AGENDA

HISTORIC PRESERVATION BOARD MEETING

**STAFF MEMORANDUM
HISTORIC PRESERVATION PROGRAM
PLANNING AND URBAN DEVELOPMENT**

TO: Chair Pollard and Members of the Historic Preservation Board
FROM: Rob Wiener, Historic Preservation Compliance Coordinator
DATE: October 28, 2022
RE: 1 Commercial Street – PUBLIC HEARING – Re-Approval of Expired Certificates of Appropriateness for Storefront Replacement and Upper Floor Rehab and Dormers
PROJECT ID: HPBR-002193-2022 (Plans Identical to HPBR-000687-2019, HPBR-000836-2019)
MEETING: November 2, 2022

2 | ENLARGED SOUTH ELEVATION
1/2" = 1'-0"

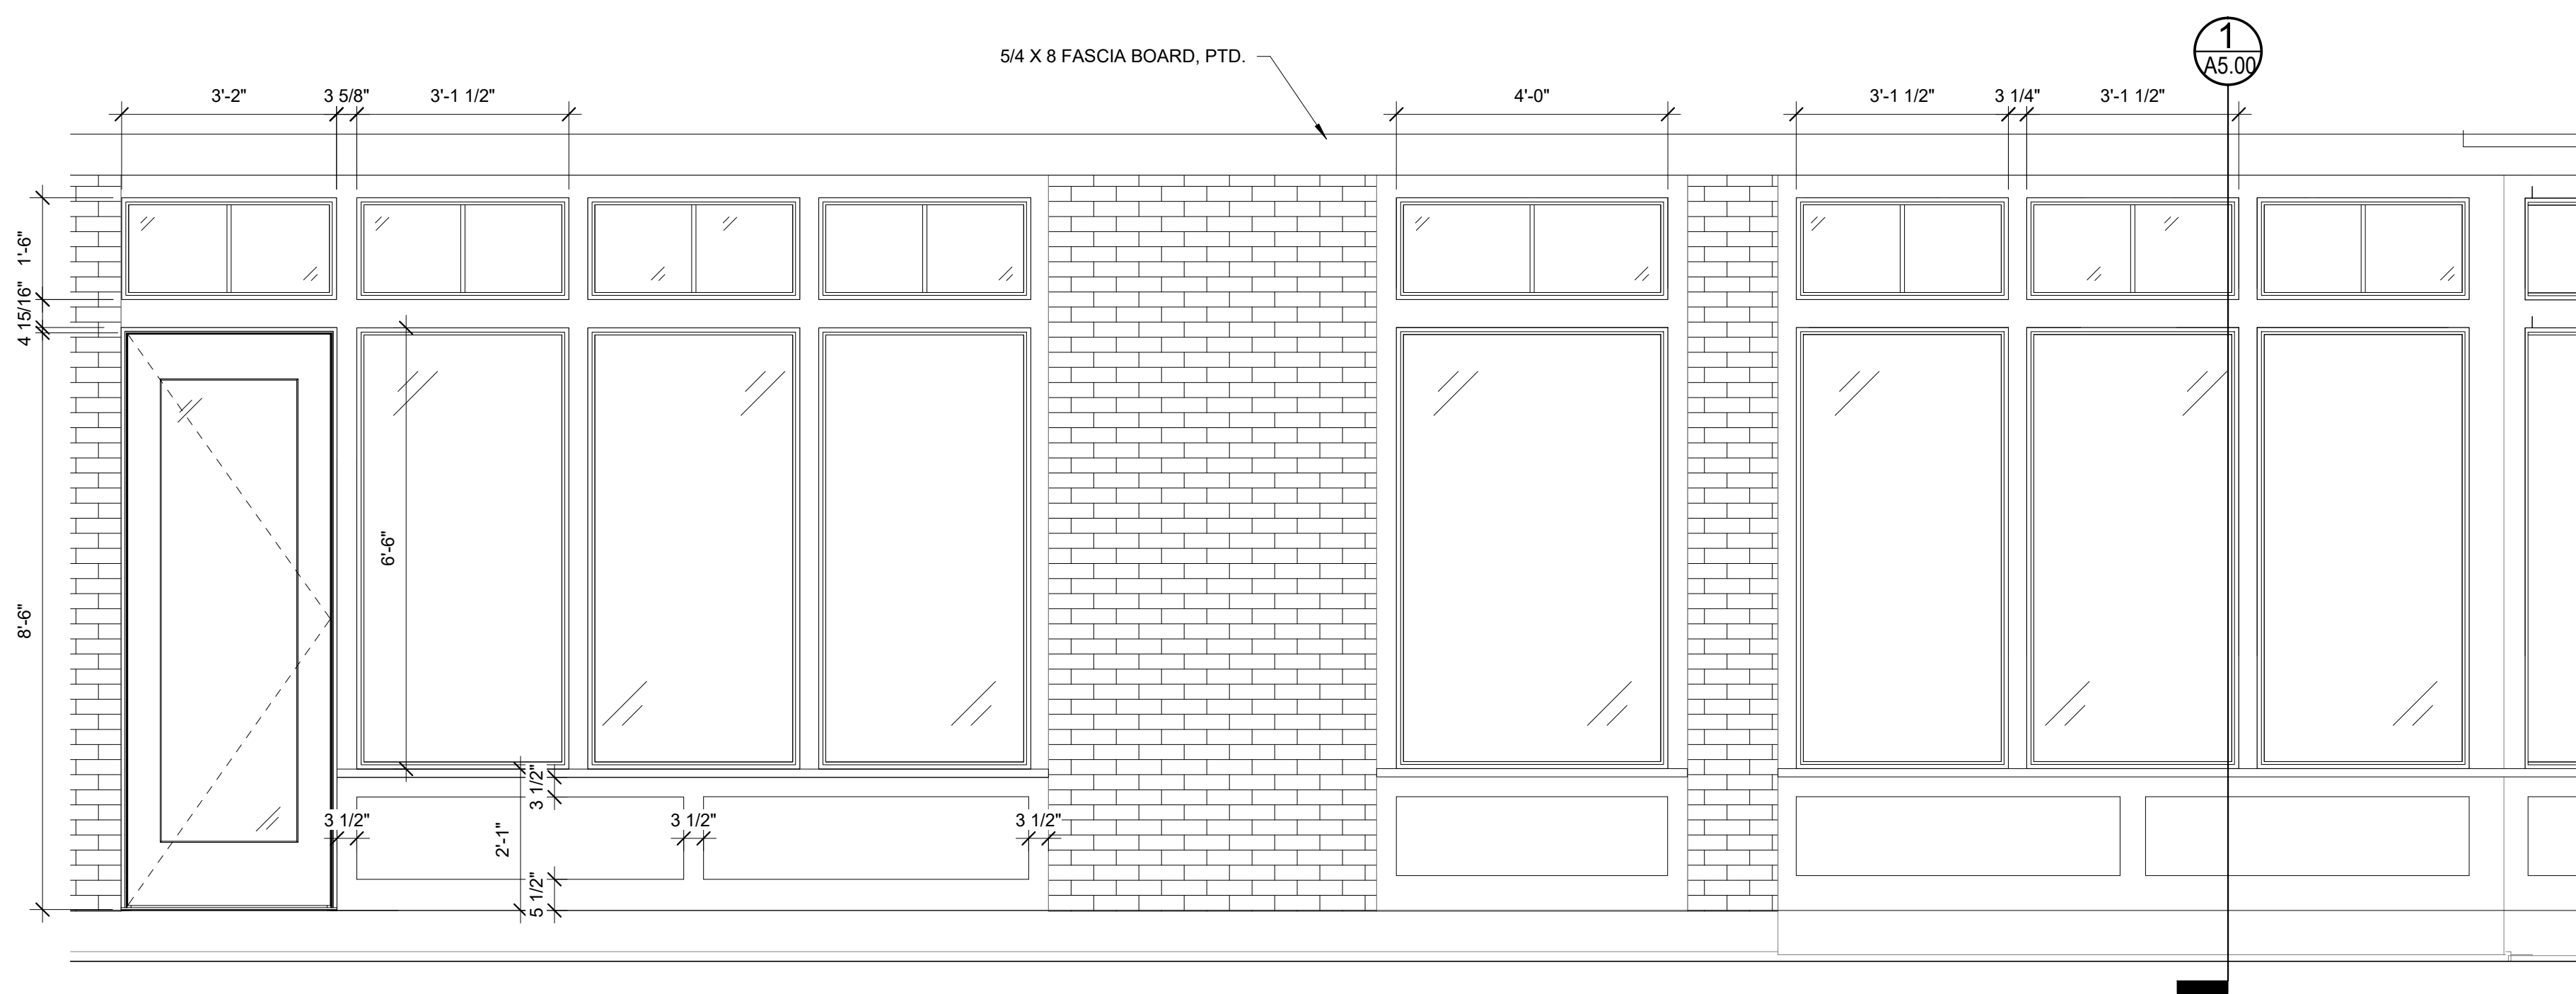
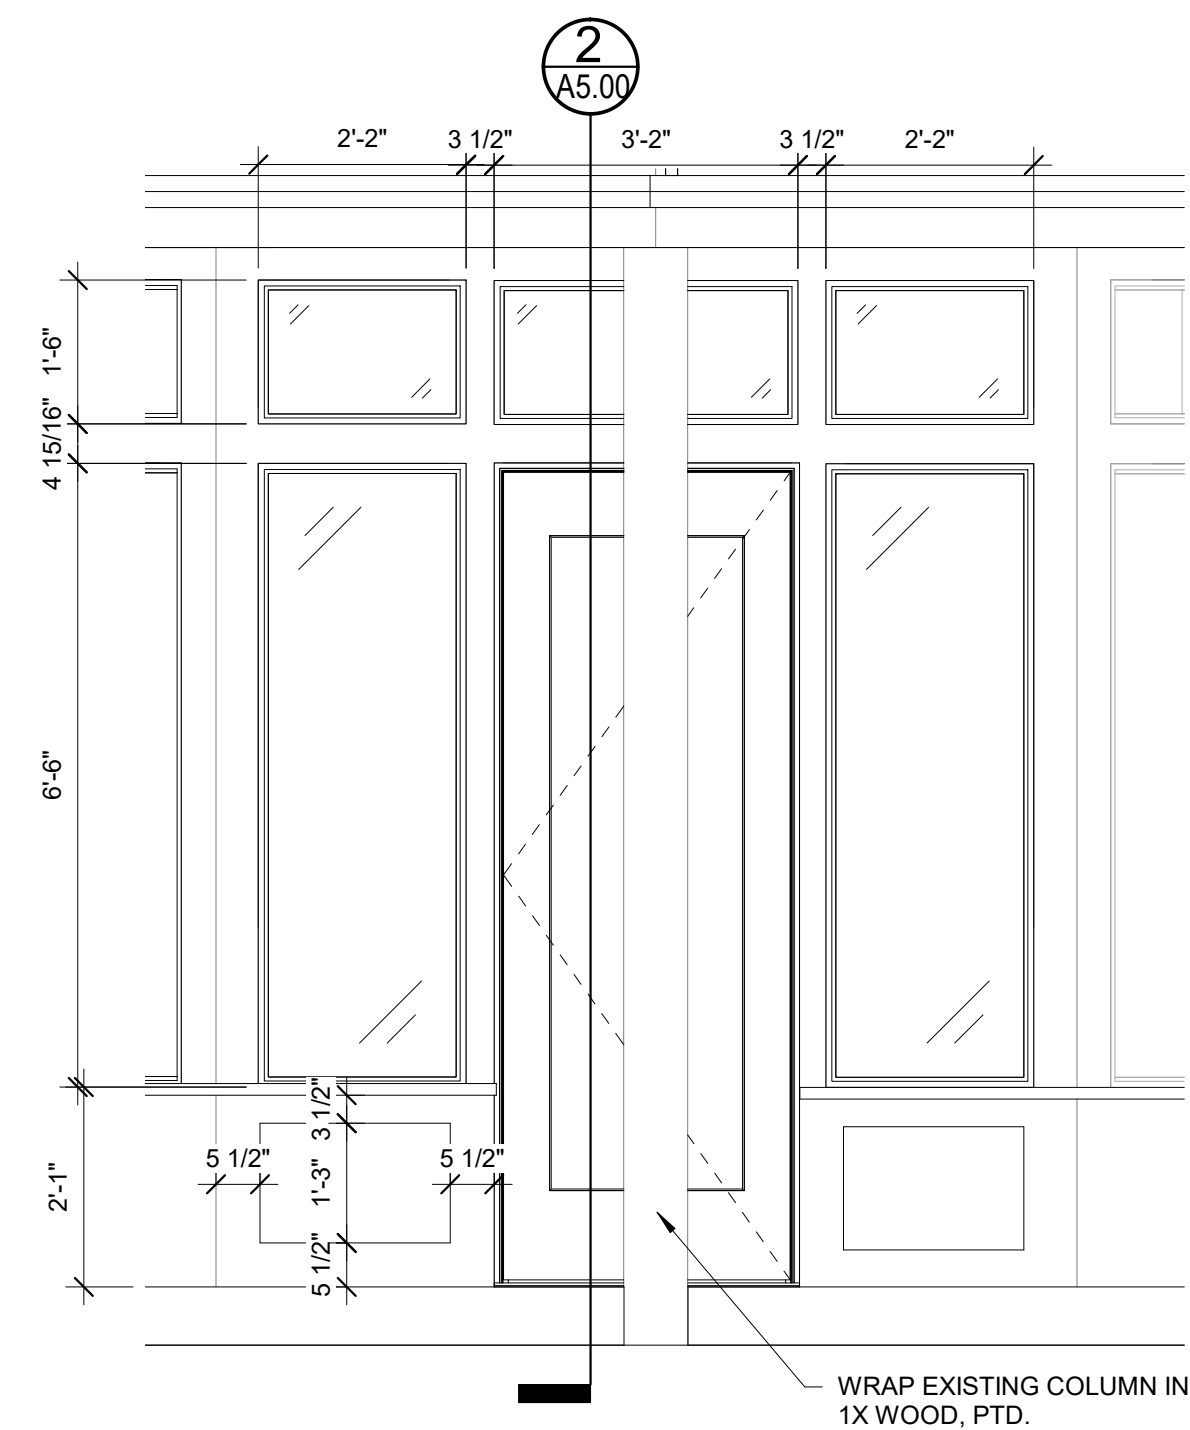
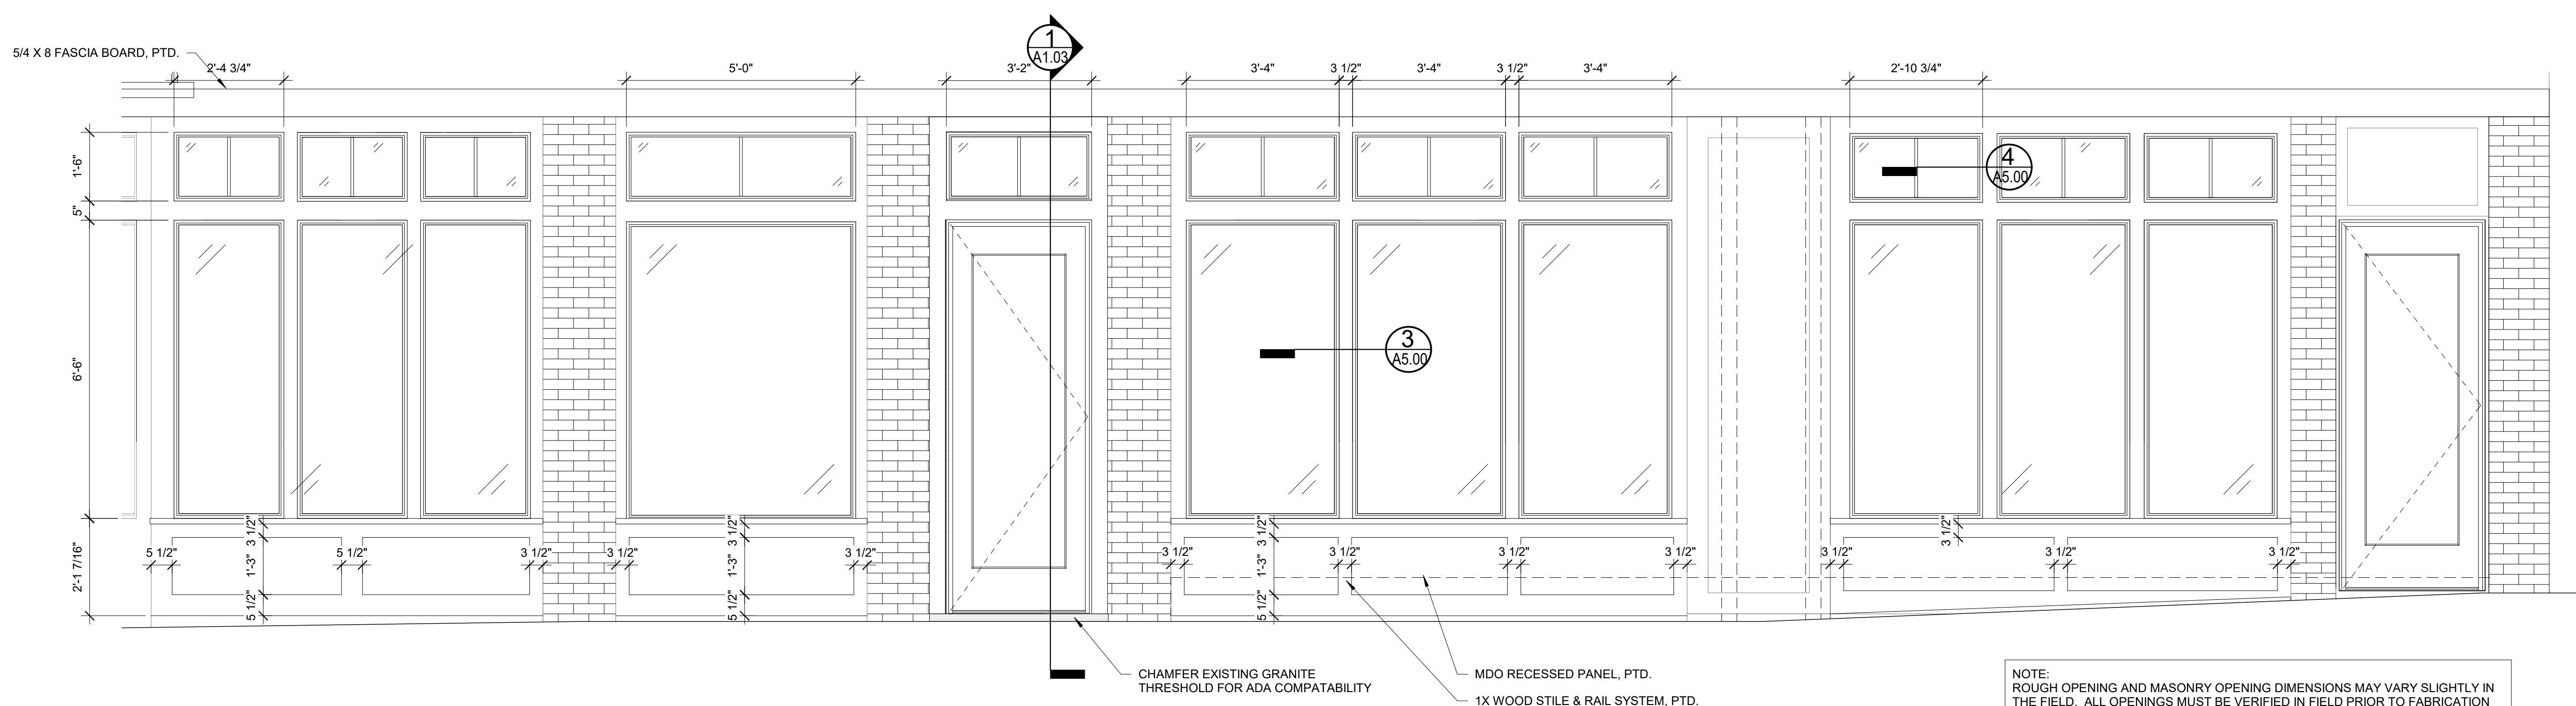
At the June 5 workshop there were more Board members uncomfortable with the incompatibility of the proposed canopy than there were in support of it. There was less of a clear majority on the question of wrapping the round steel column with wood trim. The architect stated he is unsure about the change and might prefer leaving the column as is, but the Board's decision will be accepted, either way. There was also not a clear preference on the part of Board members on whether glazing in the doors should align with the bottom of the storefront glazing.

Staff would like the Board to comment on the number of divisions and the proportions of the glass panels in the storefront bays. Because of the varied width of the different storefront bays, finding a perfectly consistent pattern of divisions and proportions may well prove difficult, so any guidance that Board members might offer on other adjustments that might be made would be helpful.

The Board seemed comfortable with the lack of an overall signage plan as part of the proposal, and there is likely to be only one tenant. Members seemed comfortable with clapboard siding continuing down to the top of the storefront trim, and signage might be proposed for the sided areas above the storefront, consistent with the appearance in the 1924 photo.

- Final detailed plans of the following are to be submitted to HP staff for review and approval, prior to construction:
 - Storefront window divisions
 - Column treatment at front corner of building
 - Bulkhead and door details
 - Any changes to exterior signage or lighting
